Town of Parker Community Development Department
Development Review Division
Attention: **Julia Duncan**

Application Type: **Site Plan**
Status: **First Referral**
Application Name: Douglas 234 F6 L2 – Car Wash
Case/AP#: **SP21-064**
Referral Received: June 20, 2021
Comments Due: July 29, 2021

Application Location: Southeast corner of Chambers Road and Red Sky Drive

Review date: **July 20, 2021**
Plan reviewer: **Randall L. Capra**, rcapra@parkeronline.org
Phone: 303.805.3169

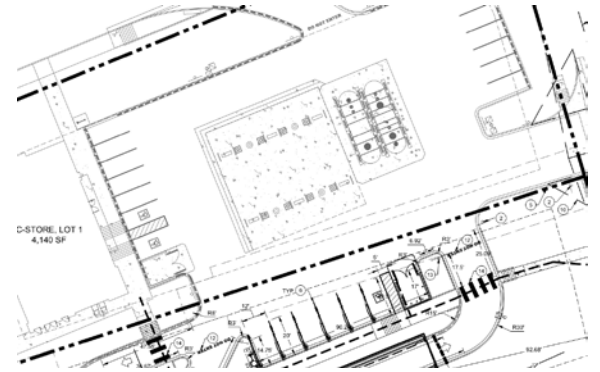
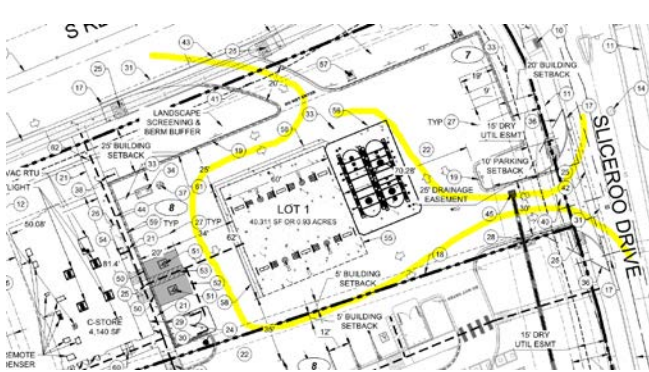
5. The applicant shall provide an auto turn analysis indicating that apparatus can navigate all portions of this site (both sides of the gas canopy); NO PARKING – FIRE LANE signage is required for any portion of the access where the 20-foot clear width requirement cannot be met. This is applicable for the loop around the canopy as well as for each entry. The access on each side of the canopy shall meet his requirement with no portion of the canopy encroaching into the required fire lane access road. See below for the areas required to be included in the auto turn analysis and address when resubmitting: *Not satisfied; applicant has stated that the auto-turn analysis and fire lane signage can be found on the Horizontal Plan in the CD set. In this case, the Horizontal Plan did not include auto-turn analysis for the area shown below in yellow. This issue shall be addressed when resubmitting.*

What is needed specific to the auto-turn analysis:

Horizontal Plan; not auto-turn analysis provided:

Not satisfied; the applicant has not addressed this issue with submittal package #3; the applicant is required to respond to this issue prior to Fire Life Safety sign off. Satisfied; applicant has addressed with current submittal.

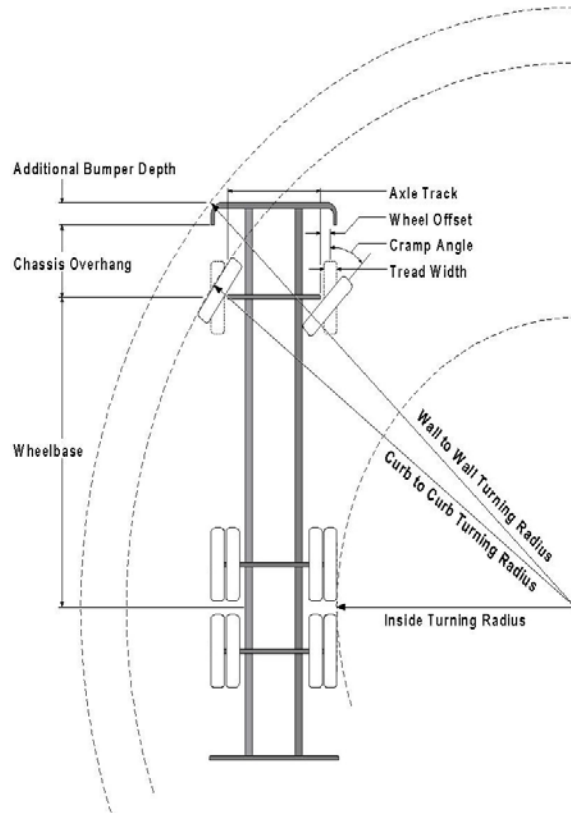
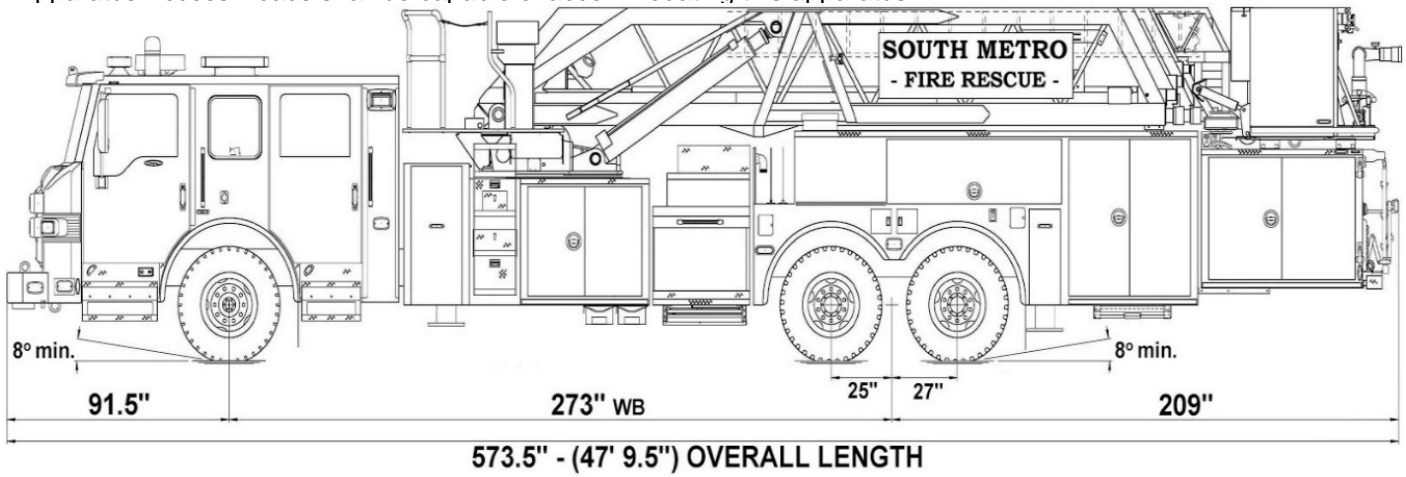
Note - An updated signature block has been created with regard to the utility drawing package; typically, this signature block is located on the cover sheet and the overall utility page of the water drawings. The signature block is noted below; address as applicable.
